INTER-DEPARTMENTAL REVIEW COMMITTEE REPORT

CONDITIONAL USE FOR A PLANNED DEVELOPMENT – YORKTOWN COMMONS

NOVEMBER 23, 2015

PC 15-27C

FIGURE 37: Parking Dimensions

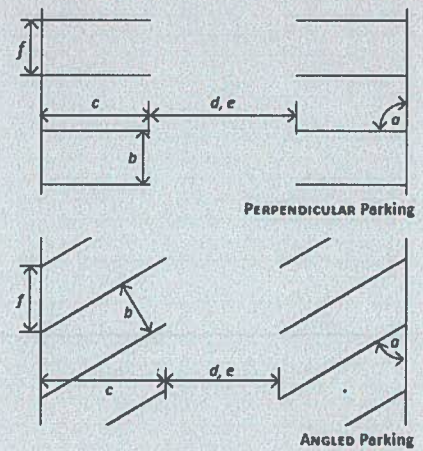
4. In Figure 37 of the Yorktown Commons Planned Development Design Guidelines (right), the petitioner proposes a parallel parking space width of seven feet (7') and a compact parking space width of eight feet (8'). The Village recently completed an update, which was researched and evaluated against modern industry standards, to the Lombard Zoning Ordinance parking dimension standards at the behest of the current property owner (see PC 14-02). The recently adopted dimensions specify a parallel parking space to be a minimum of nine feet (9') in width and the narrowest, compact parking space, to be a minimum of eight foot three inches (8'3") in width. The proposed dimensions which are more permissive in the Yorktown Commons Planned Development Design Guidelines than the existing dimensions in the Lombard Zoning Ordinance are highlighted in red.
